772: Leather Lane – Structural Inspection

We write following our visit with you and our mutual client to the upper apartment at 87 Leather Lane, Clerkenwell, EC1N 7TS on the 13<sup>th</sup> September this year to confirm our comments made during the visit.

Fig. 3 : Notching to existing floor joists

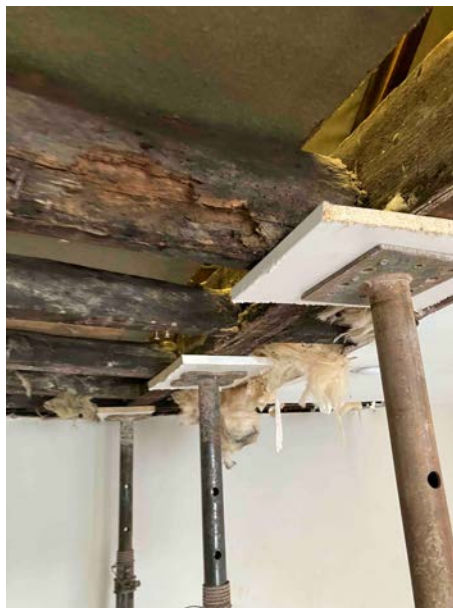
At the second floor level where the previous bathroom fit out had been removed there is evidence of notching to the existing floor joists (see fig. 3). Although the notching seen in this location is reasonably significant the span of the joists in this part of the building is reasonably small and the joists here were relatively substantial (measured in this location at 75 x 195mm at 360mm c/c.). The joists in this area did not show any significant signs of structural distress relating to this existing notching.
